WEST BAGHDAD INTERNATIONAL  
AIRPORT SPECIAL FORCES BARRACKS  
BAGHDAD, IRAQ

SUSTAINMENT ASSESSMENT

**SIGIR PA-07-100**

SUBJECT: Report on West Baghdad International Airport Special Forces Barracks,  
Baghdad, Iraq (Report Number SIGIR PA-07-100)

**Site Photo 6. Clear water backed up in floor drain of company barracks.**

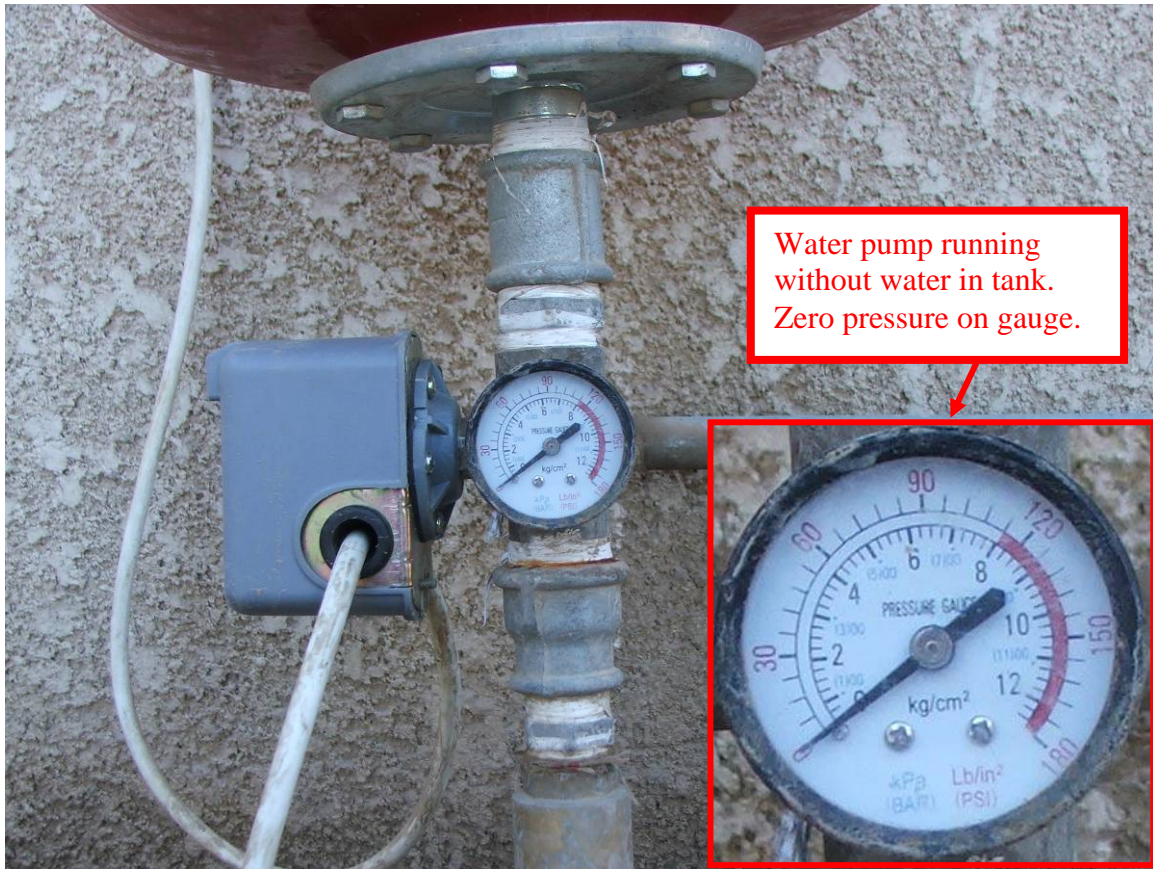
Site Photo 6 shows the clear standing water on the floor of a barracks bathroom.

SIGIR inspectors examined the outer septic holding tank of the bathroom in Site Photo 6. Outside the barracks, in Site Photo 7, the bathroom septic holding tank did not appear to be full. With only a partially filled holding tank, the standing water appeared not to be septic backup. Accordingly, the water standing in the drain was clear which also indicates the backup was not septic system water.

**Site Photo 10. Four generators installed but not operational during site visits.**

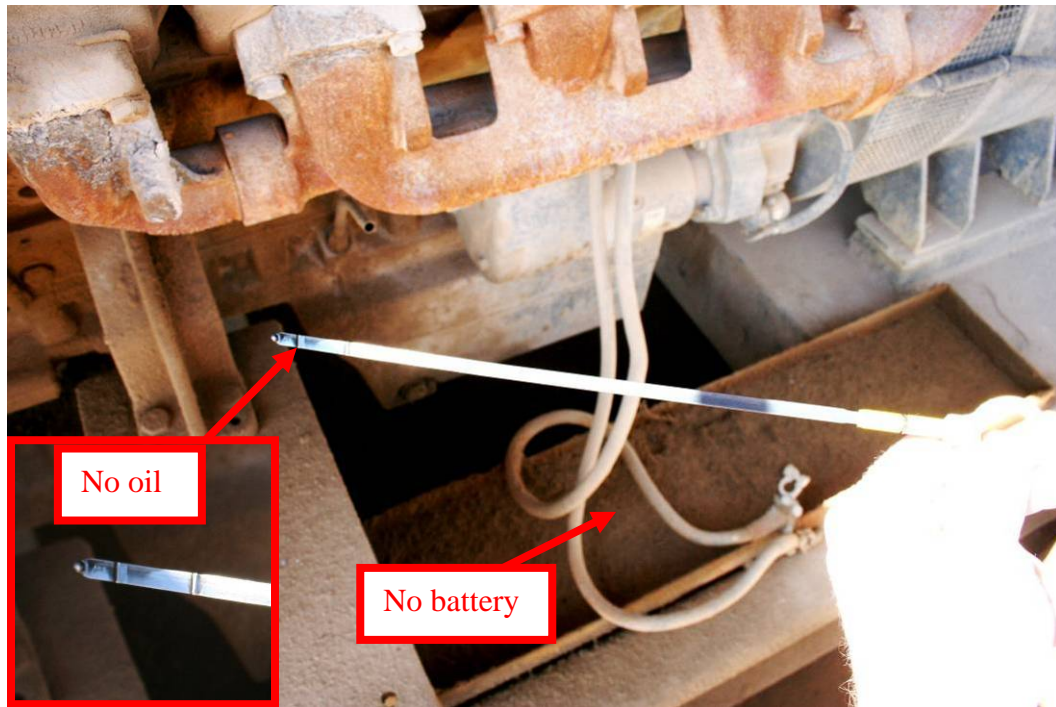
SIGIR inspectors found four 150 kilovolt generators present on site (Site Photo 10.) According to USACE provided documentation, each generator cost approximately \$50,000. The generators included three fuel storage tanks and electrical switching equipment.

All four generators did not function when inspected. Inspection of the generators revealed missing or nonfunctional batteries in all generators. The generators also contained an inadequate amount of oil. In Site Photo 11, a generator shows an empty battery and a dipstick with no oil.

It is likely that the generators were functioning at one time as spots of oil were visible under generators one and three. The exhaust pipes and mufflers on generators one and three also contained a higher degree of rust than generators two and four, which indicated that generators one and three ran more than generators two and four. The nonfunctional generators lacked batteries and oil, and the fuel tanks were empty.
